**Atchison Street
St Leonards, NSW**

Department Letter Response

Our ref: Shop Top Housing – 20-22 Atchison Street (SSD-87486461)

Subject: Department's Key Issues

Mitchell Street Square – failed greenwall with westerly aspect

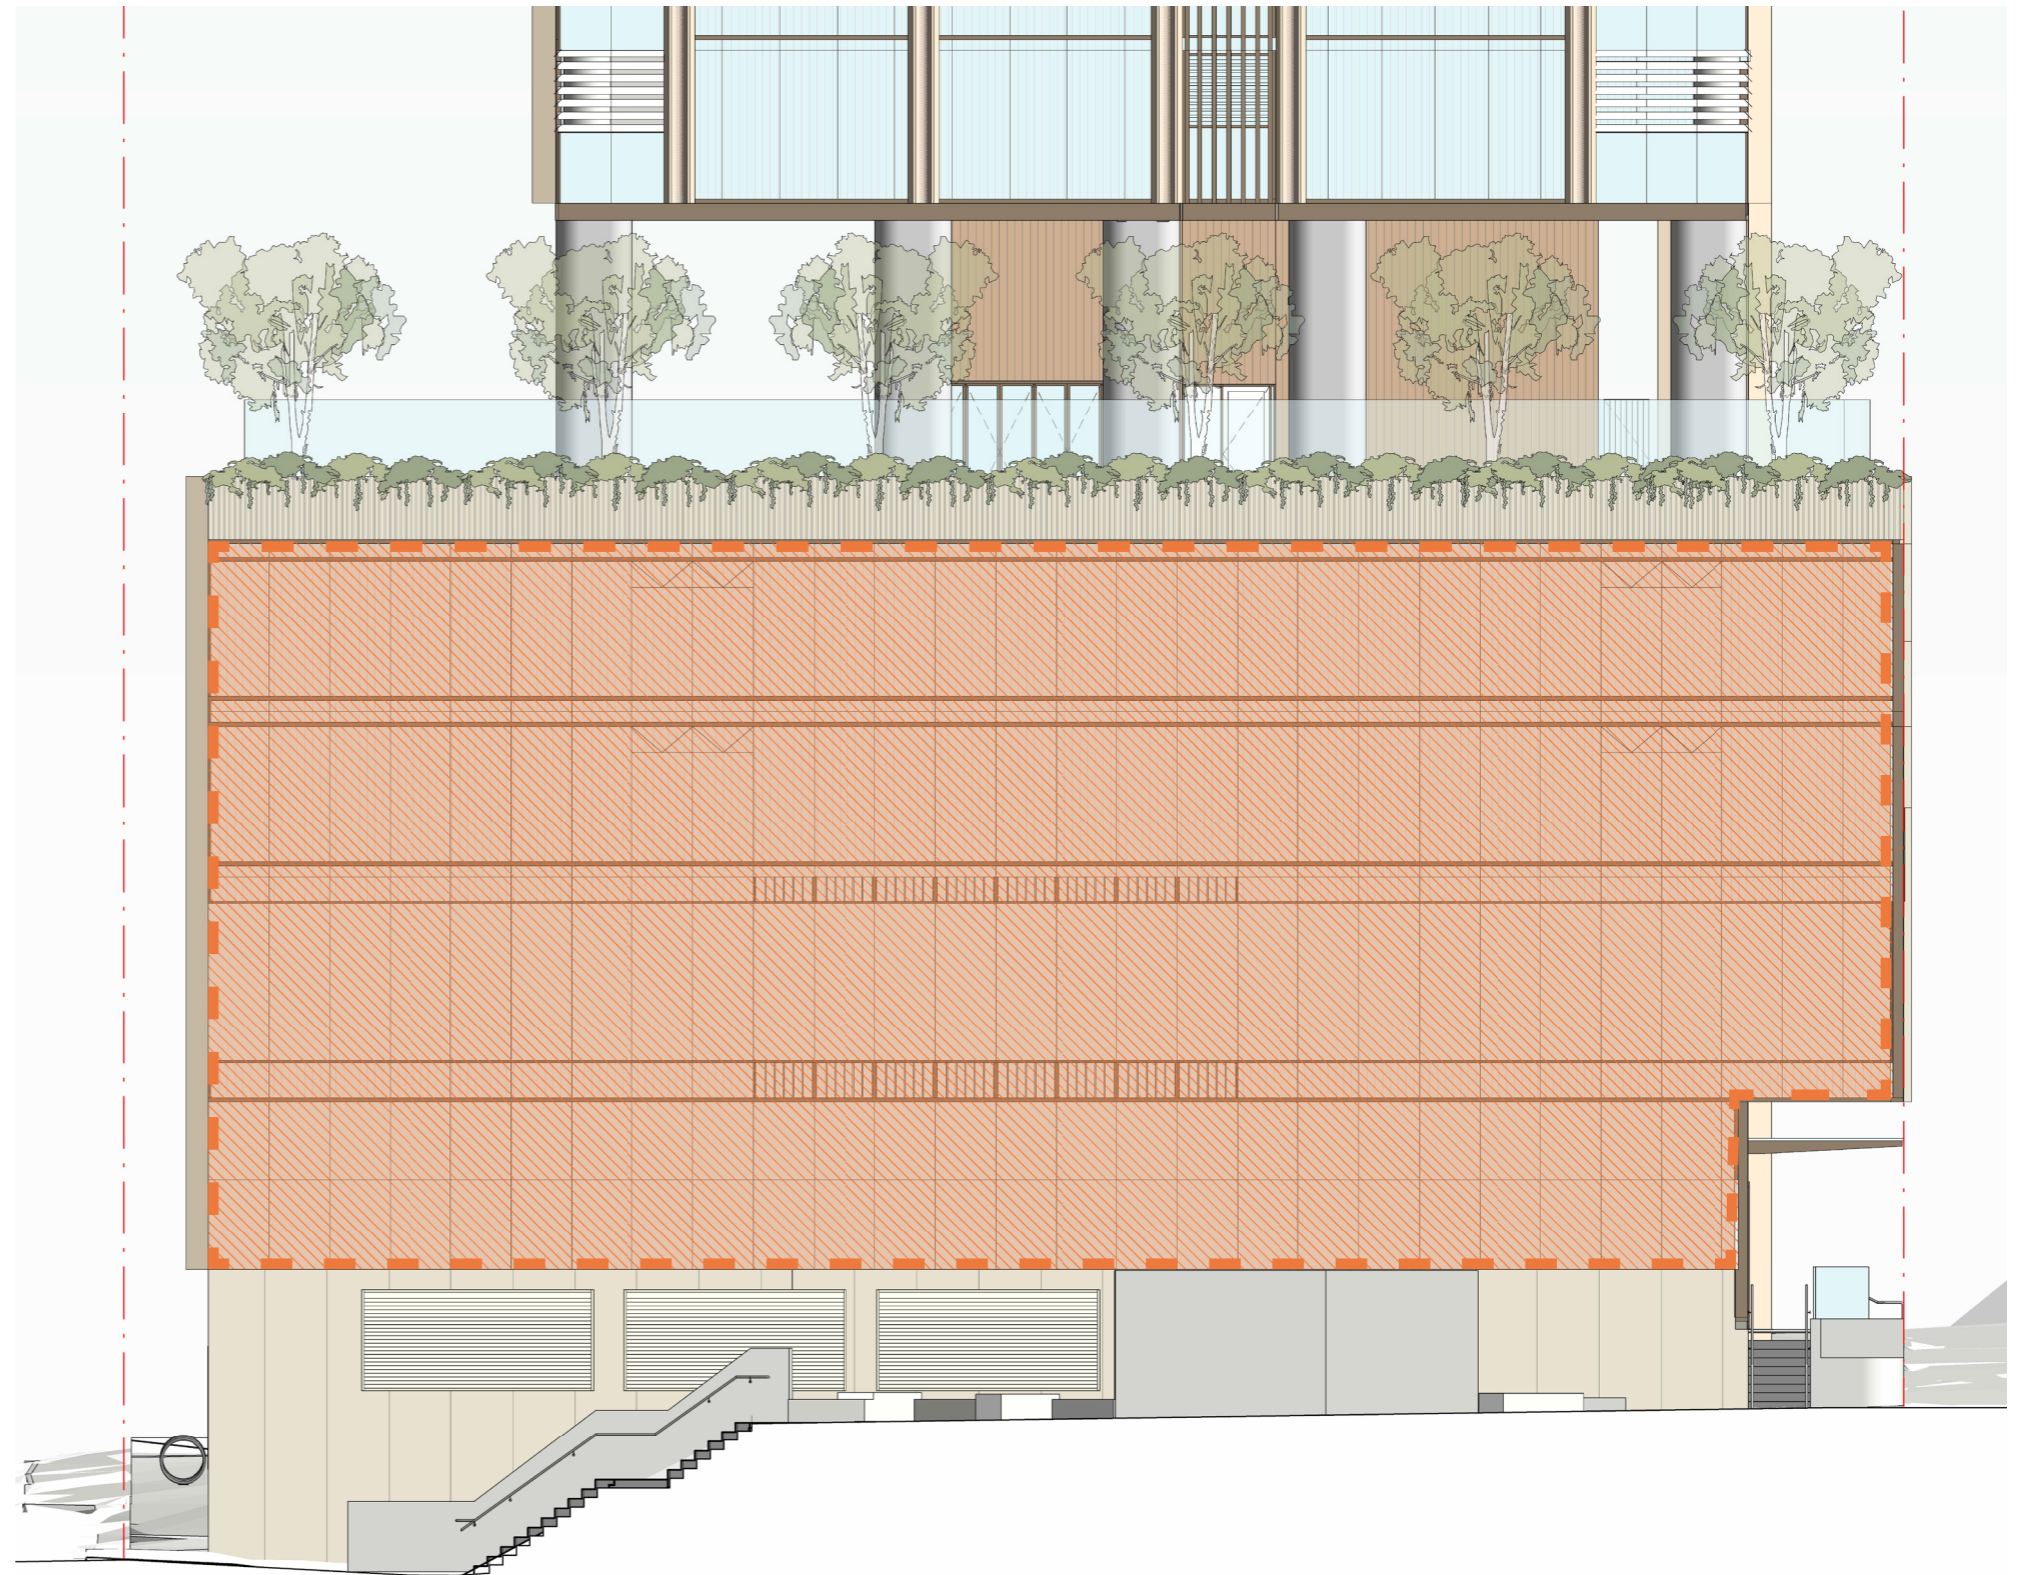
We refer to the Department's request for consideration of additional street activation and/ or landscape treatment along the western boundary of the site, specifically the potential for a green wall or similar planting measure to screen the inactive facade. We appreciate the intent of the comment and have undertaken a detailed review of opportunities within this interface. Based on prevailing environmental conditions, site geometry, and comparable local precedents, we provide the following advice regarding the feasibility of implementing a successful green wall or significant landscaping treatment in this location.

Given that the Mitchell Street example benefitted from superior growing conditions yet was unable to remain viable, it is reasonable to conclude that a new green wall on the proposed development's western façade—within a harsher environment—would face an even higher risk of failure.

Due to the zero-lot boundary condition, highly unfavourable microclimate, and demonstrated failure of a nearby green wall exposed to less harsh conditions, the installation of a green wall or additional landscaping along the western façade is not considered feasible or likely to achieve a successful long-term outcome. Alternative activation strategies are recommended to better satisfy the intent of the Department's comment without incurring substantial risk of planting failure.

Existing Section
NTS

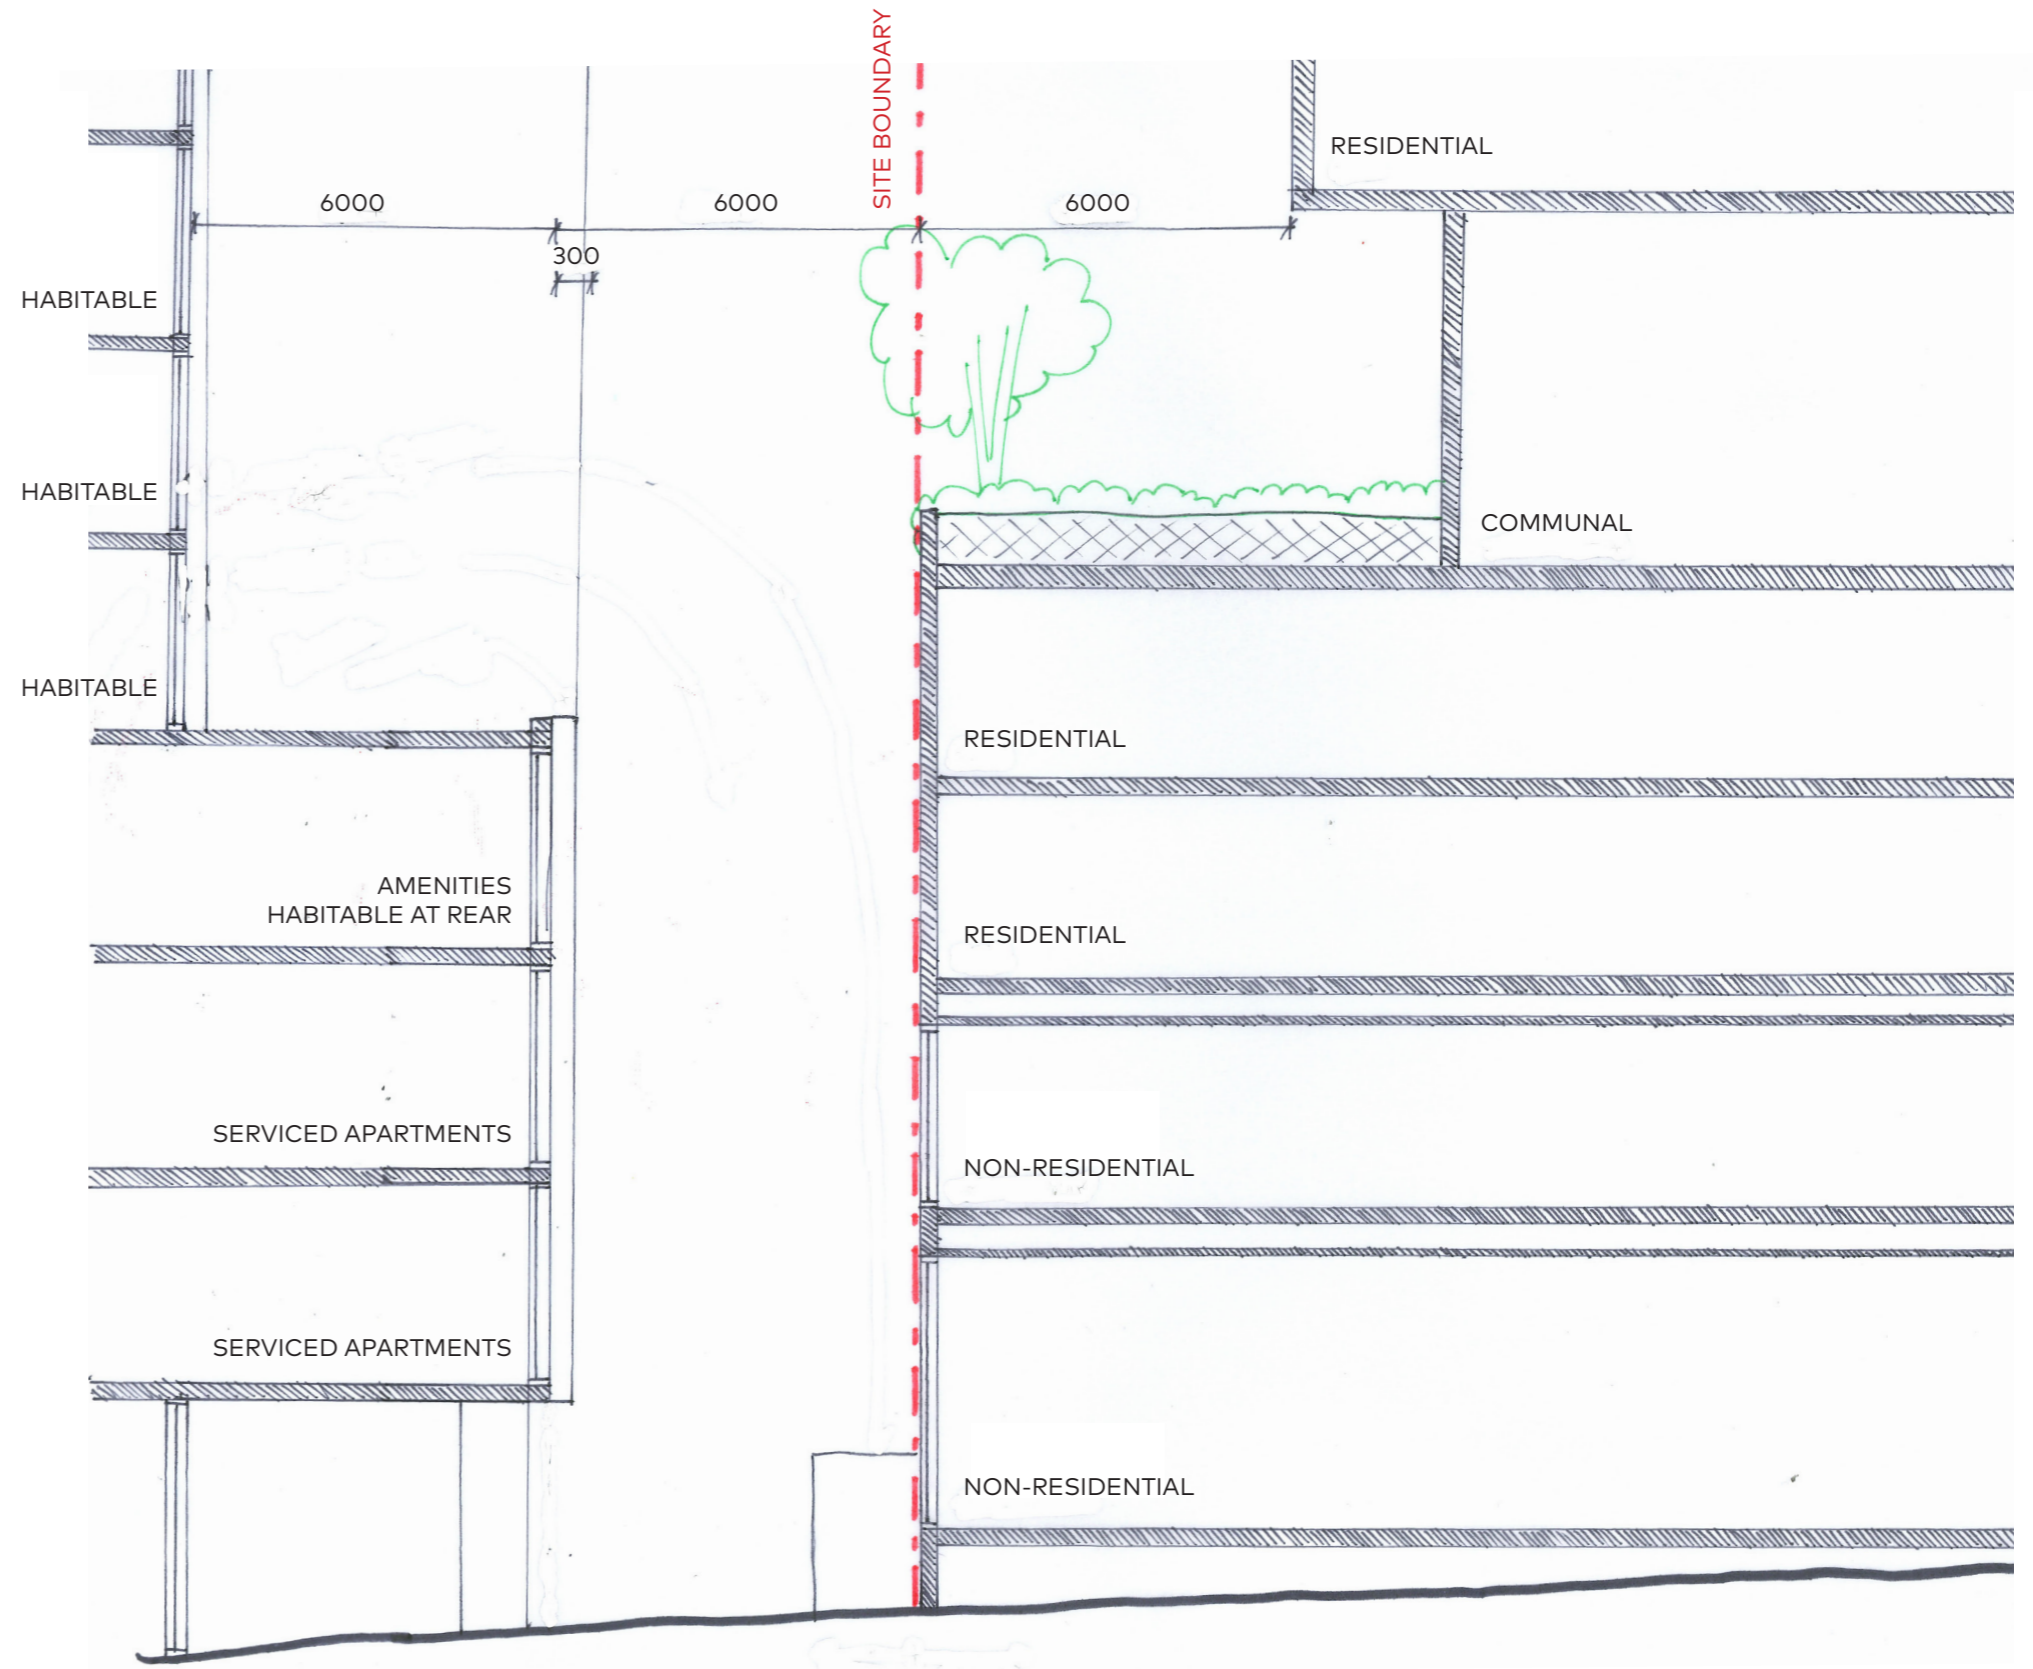
- b. Consider increasing setbacks for the residential podium Levels 2 and 3 to more closely align with the building separation distances recommended in the Apartment Design Guide (ADG).**

COX Architecture have considered three options for the podium along the western boundary fronting the through-site link at 6-16 Atchison Street. The first, and preferred option, is the existing arrangement, which is thought to be the best design outcome for the following reasons:

- Achieves a four level podium to west, south and east elevations as per the Design Guide.
- Zero setback from western boundary as per the Design Guide.
- Maximises Communal Open Space to Level 4 on top of podium, and usability of this communal space.
- The proposed solid wall/ non-habitable spaces along western boundary ensure no privacy issues created to 6-16 Atchison Street, which is predominantly services apartments and amenity space at podium level.
- Proposed built form proportions are well balanced, and consistent across elevations.
- Western boundary apartments have equal amenity to other podium level apartments in the proposal, 70% of which have a single aspect arrangement.

The second option considered setting back Levels 2 and 3 from the western boundary to provide a consistent 6m offset from boundary for all residential spaces. This option is not preferred for the following reasons:

- Inconsistent podium height to other elevations, 2 storey on western elevation, 4 storey on south and east.
- Western podium not in line with 4 storey podium requirement as per the Design Guide.
- An isolated notch out in podium looks unintentional.
- Level 2 windows are over 12m above the adjacent existing ground level, western wall of Levels 2 and 3 required to be retained as solid to meet ADG separation requirements, meaning there is no increase to amenity of the units in this location.
- Reduction in residential storage space on Levels 2 and 3 result in this needing to be made up elsewhere in the proposal.
- Reduction in Level 2 and 3 floor plate results in the creation of 2x studio apartments and 2x four bedroom apartments in the podium which are inconsistent with the developments unit types.

The third option considered setting back the podium a consistent 6m from the western boundary, this option is not preferred for the reasons above, as well as:

- Bringing the tower form to the ground along the western elevation is inconsistent with the other three podium elevations and with the Design Guide constraints.
- Further reduces non-residential GFA by reducing the floor plate at Ground Floor and Level 1, exacerbating the existing variation to the non-residential FSR control.
- 6-16 Atchison Street existing services would be floating in the middle of the widened through-site link.
- Lower Ground Floor vehicle entry and loading dock heights are impacted by the lower ground level of the 6m setback zone. The Lower Ground Floor will be will not function in its current arrangement and require re-planning the already tight space.

West Elevation NTS

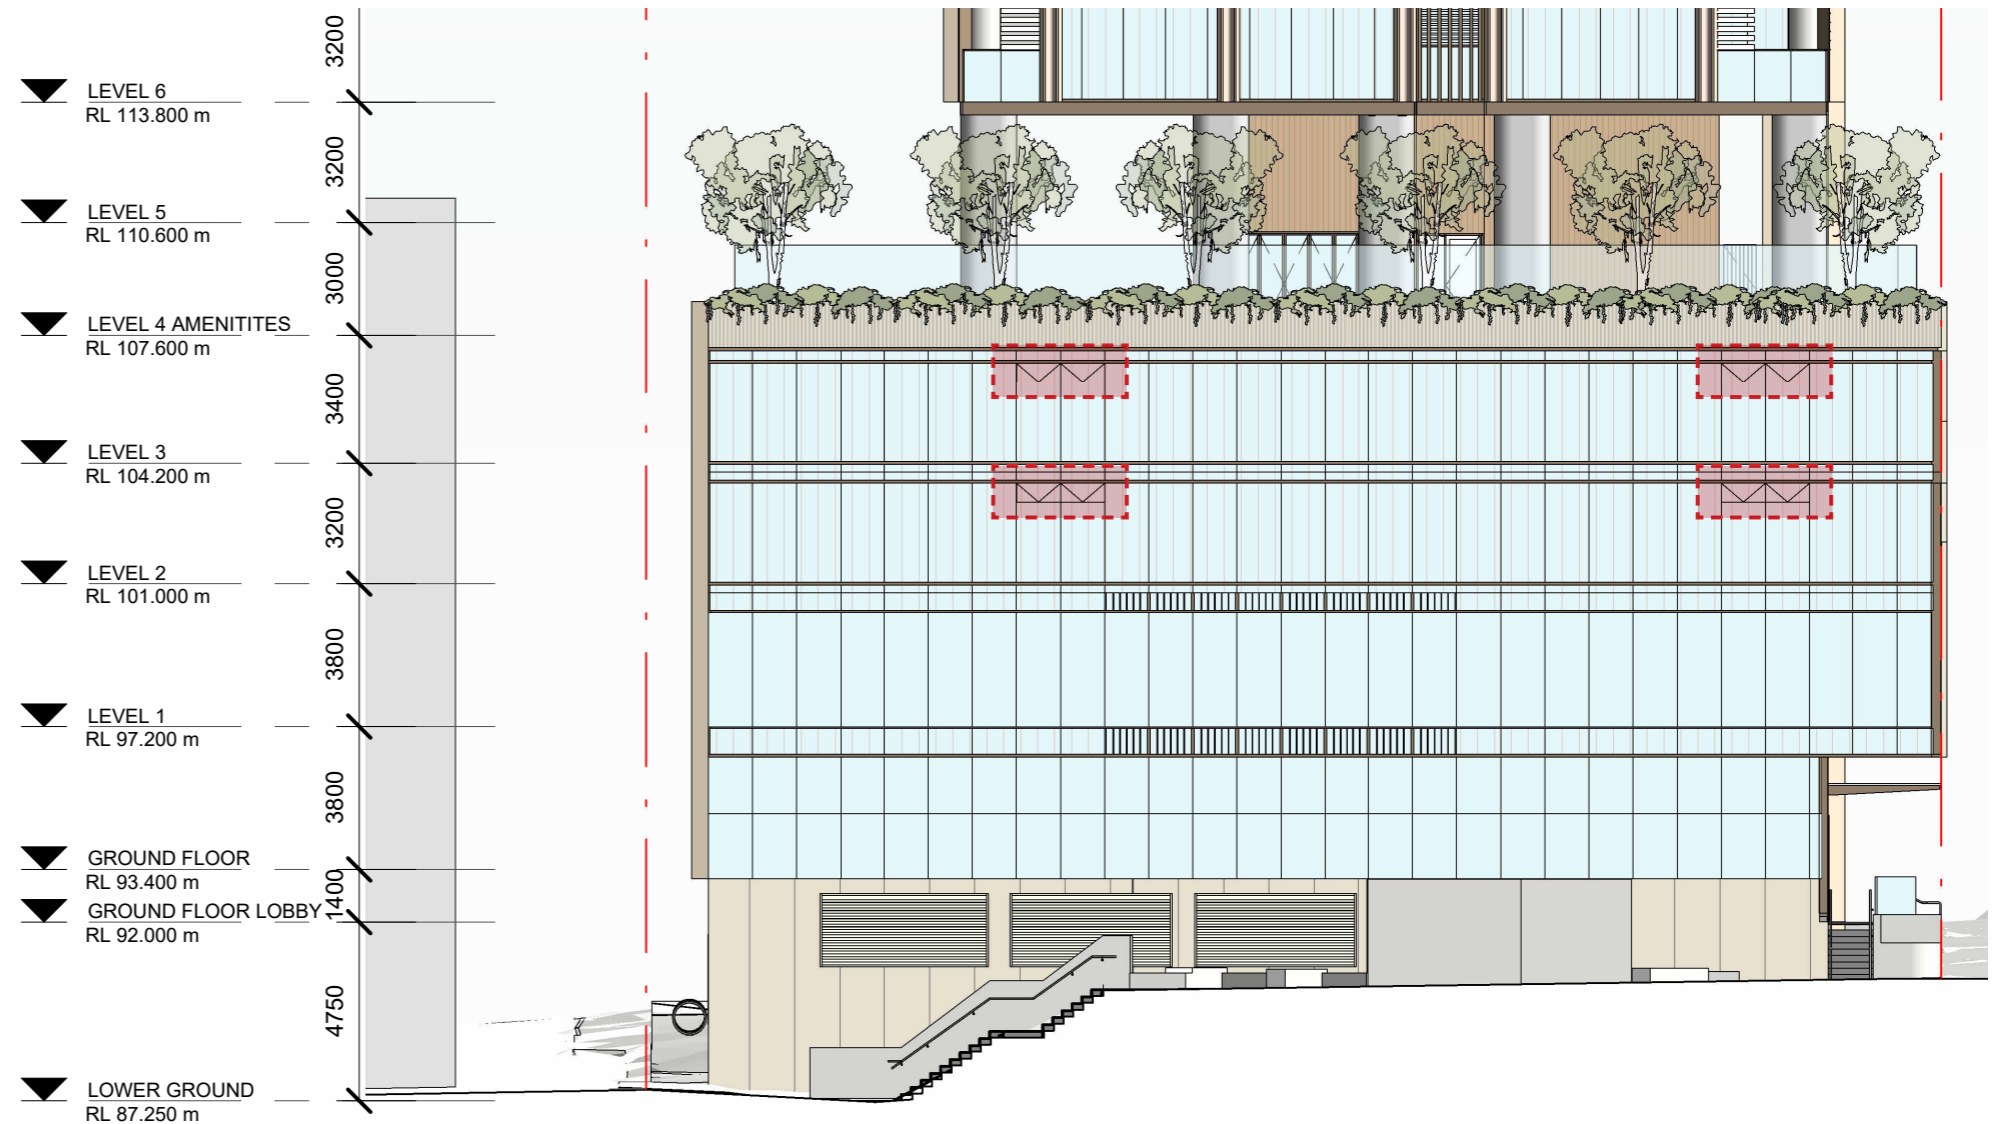
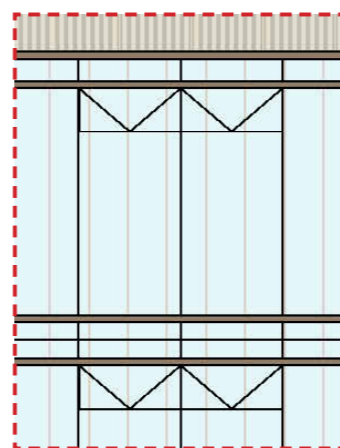
- c. **Confirm that the apartments identified as achieving natural cross ventilation can achieve this, as recommended in the ADG. Particularly the apartments on Level 2 and 3 given the western elevation of building is a solid wall.**

As per SSDA submission, the cross ventilation approach is to have operable awning panels at high level to facilitate cross ventilation while not providing views to neighbouring building.

Level 2 Cross Ventilation Plan
NTS

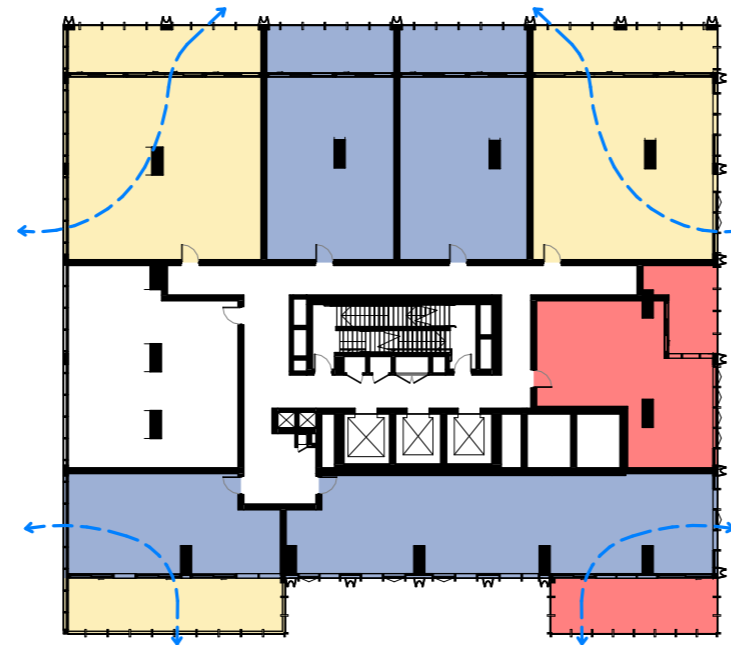
- c. **Confirm that the apartments identified as achieving natural cross ventilation can achieve this, as recommended in the ADG. Particularly the apartments on Level 2 and 3 given the western elevation of building is a solid wall.**

↔ NATURAL CROSS VENTILATION	4
TOTAL NO. OF UNITS	7
